### Five County Stadium - ADA Phase 2

Project No. RFB #25-070

#### **ADDENDUM 02**

A203

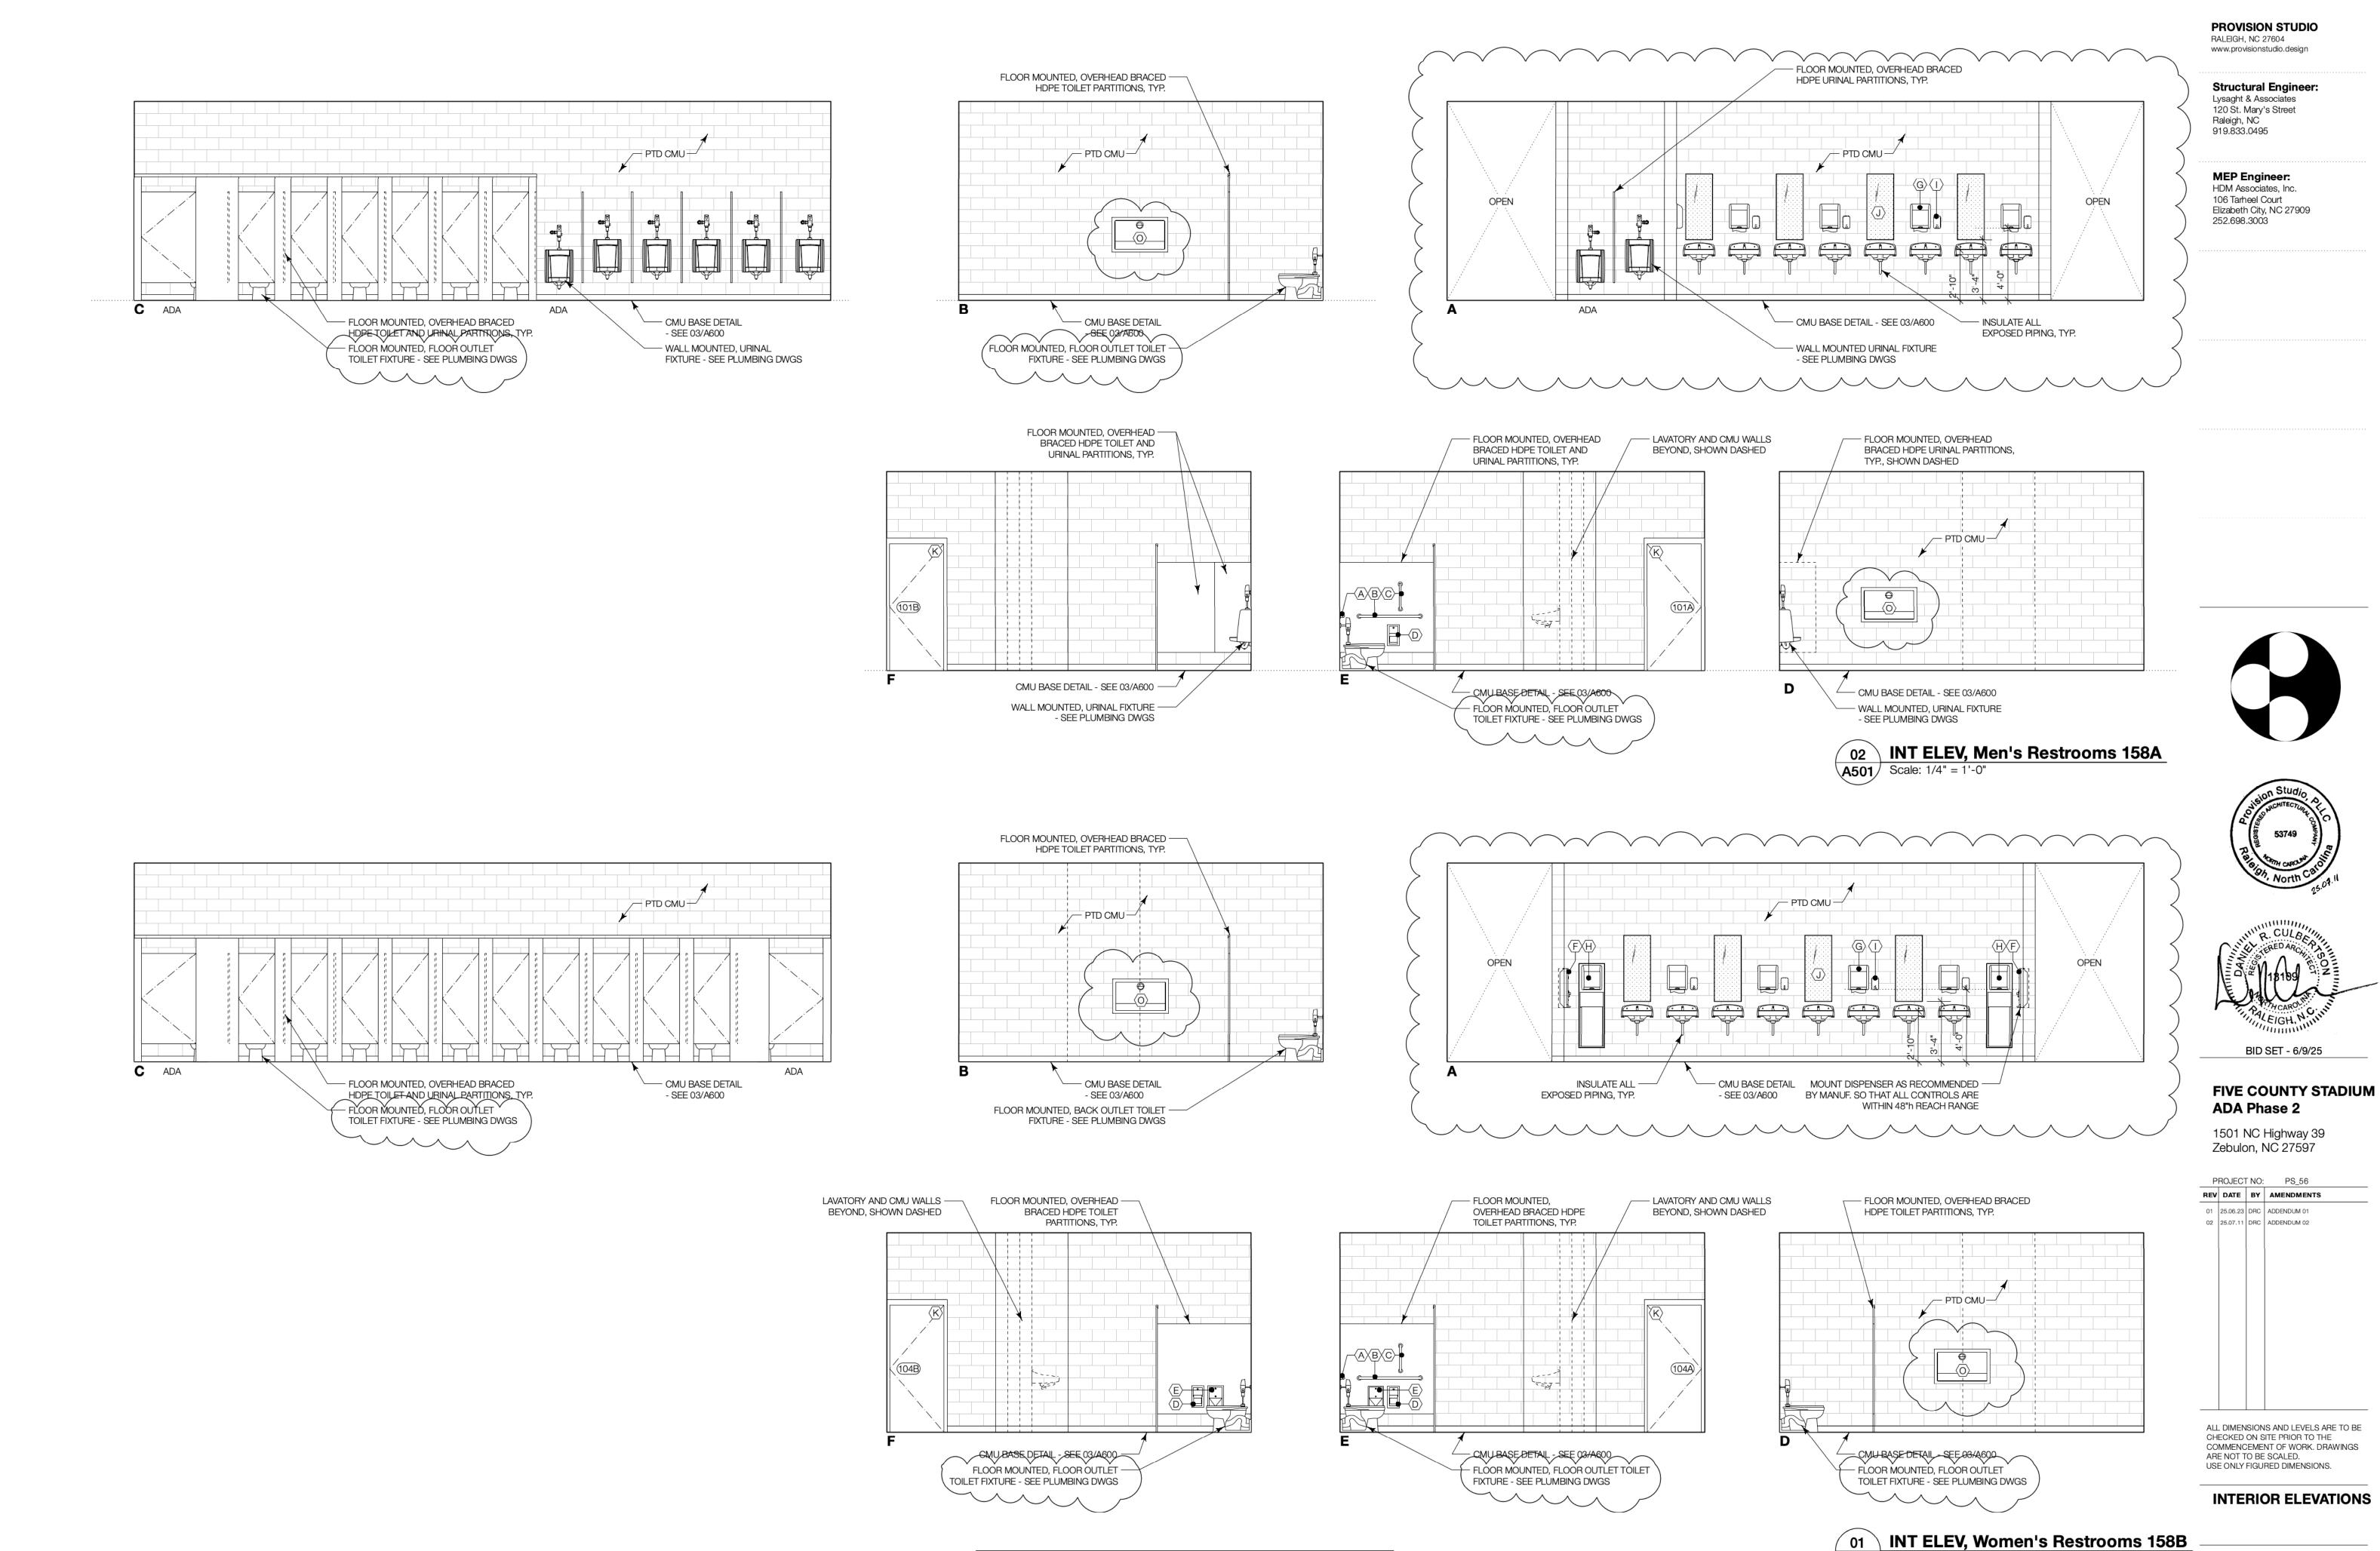
- A203 Floor Plan
  - Restroom accessories 'F' and 'O' are now visually shown on the floor plan 02/A203 for 250G Men's and 251G Women's restrooms as applicable.

**A501**

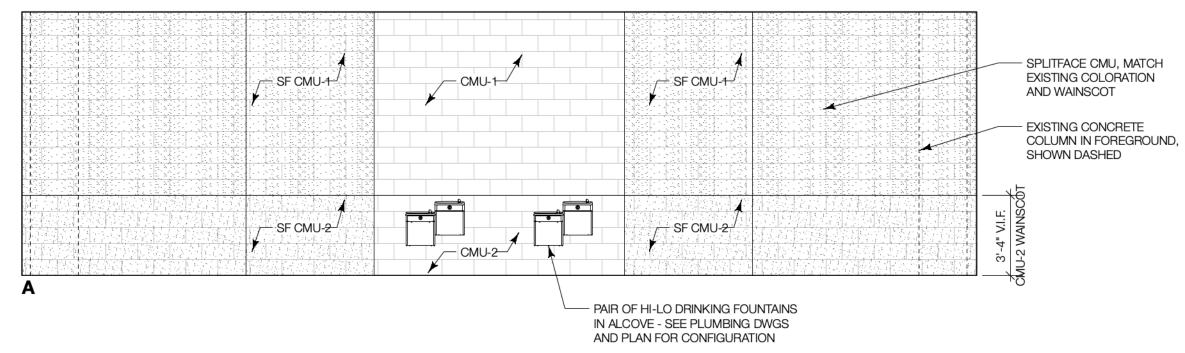
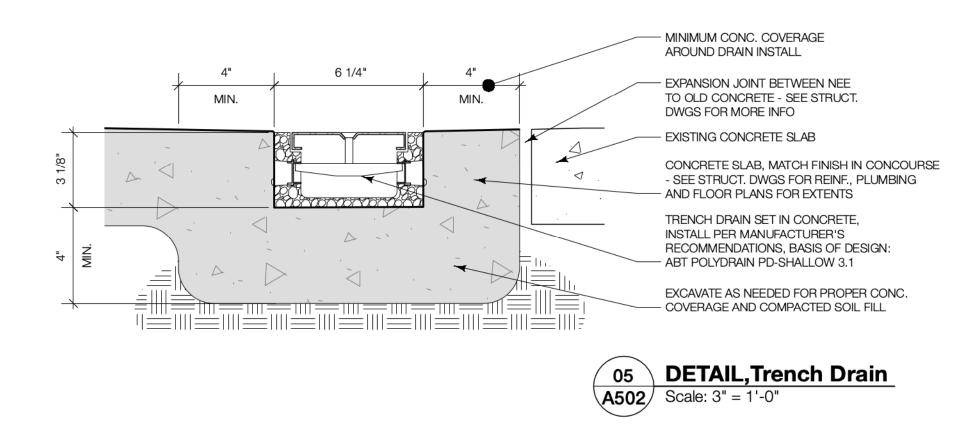
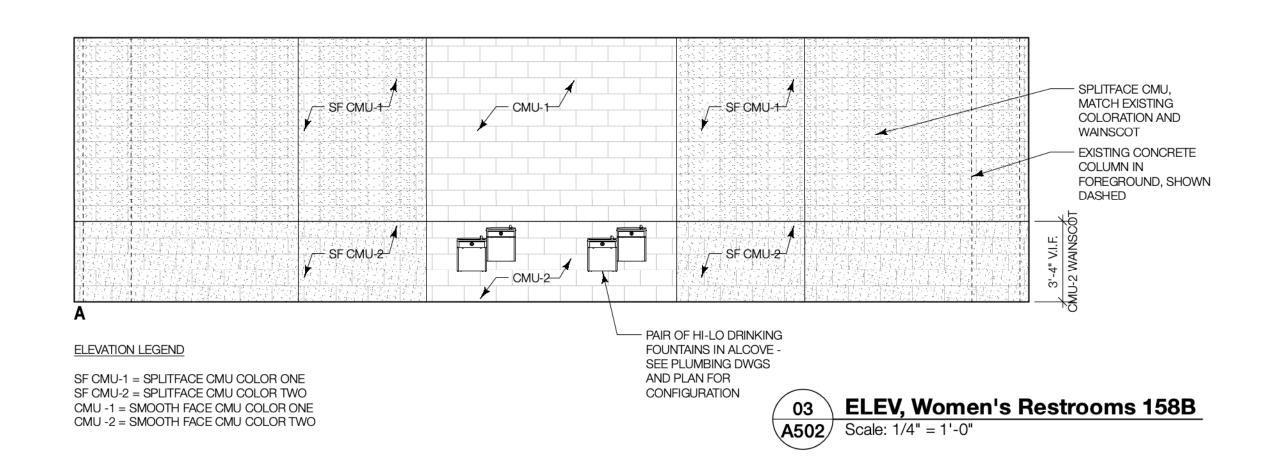
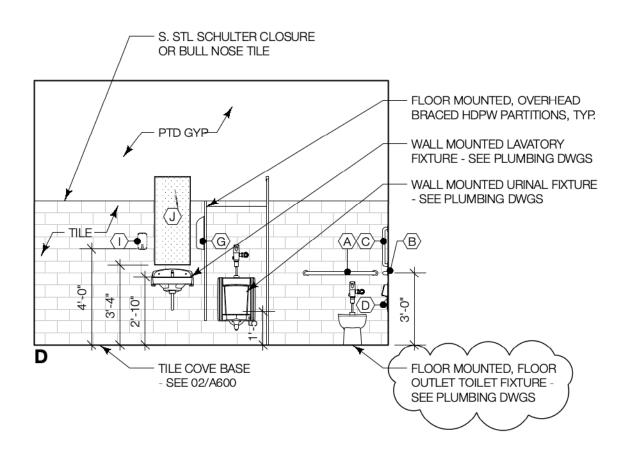
- A501 Interior Elevations
  - Toilet fixture callouts have been revised to read 'Floor mounted, floor outlet toilet fixtures see plumbing dwgs.'
  - o 01/A501 Interior Elevation A is revised to correctly coordinate with the lavatory and accessories quantity and arrangement indicated on the Floor Plan 02/A202.

- o 01/A501 Interior Elevations A, B and D are revised to visually show restroom accessories 'O' and 'I' that are indicated on Floor Plan 02/A202.
  - o 02/A501 Interior Elevations A, B and D are revised to visually show restroom accessories 'O' and 'I' that are indicated on Floor Plan 02/A201.

**A502** Scale: 1/4" = 1'-0"

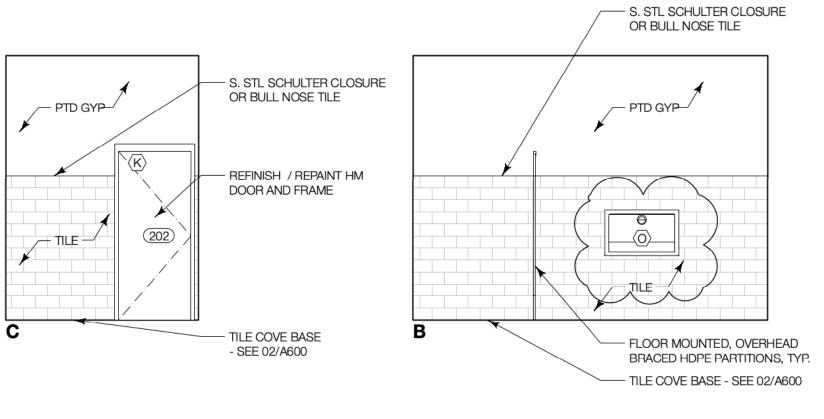
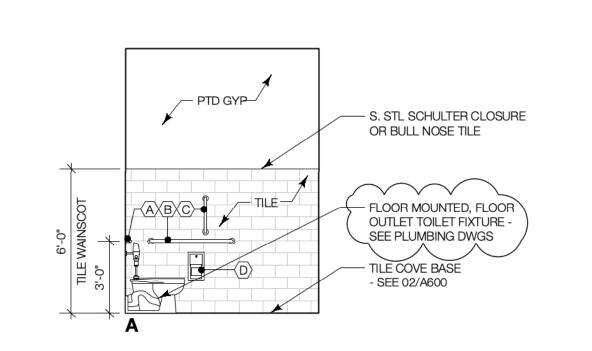
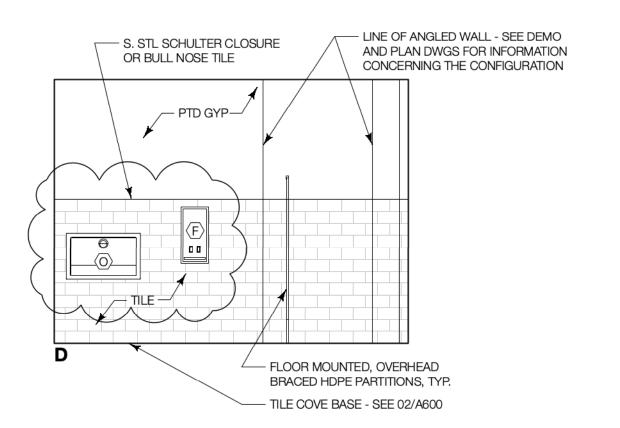
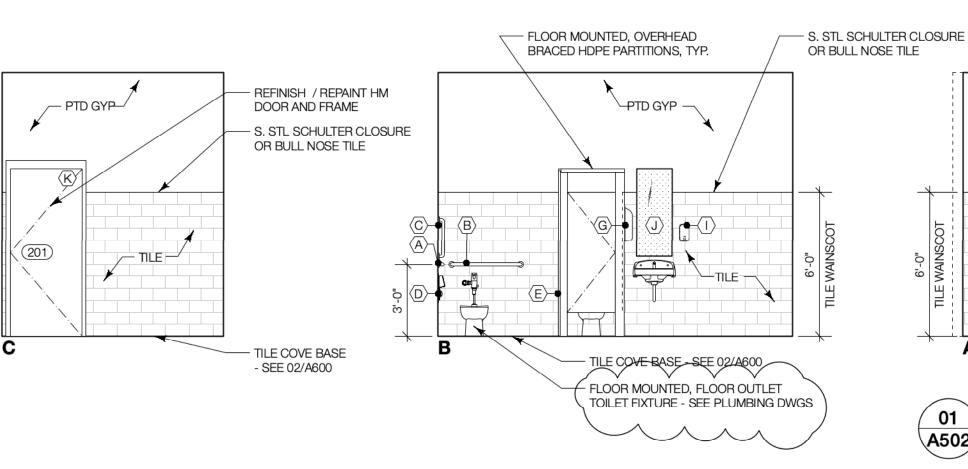
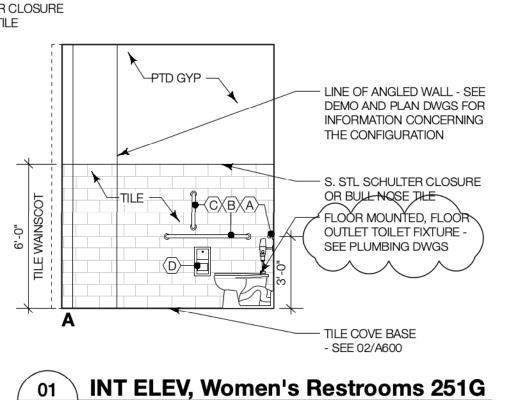
- Toilet fixture callouts have been revised to read 'Floor mounted, floor outlet toilet fixtures - see plumbing dwgs.'
- o 01/A502 Interior Elevations D is revised to visually show restroom accessories 'O' and 'F' that are indicated on Floor Plan 02/A203.
- o 02/A502 Interior Elevations B is revised to visually show restroom accessory 'O' that is indicated on Floor Plan 02/A201.
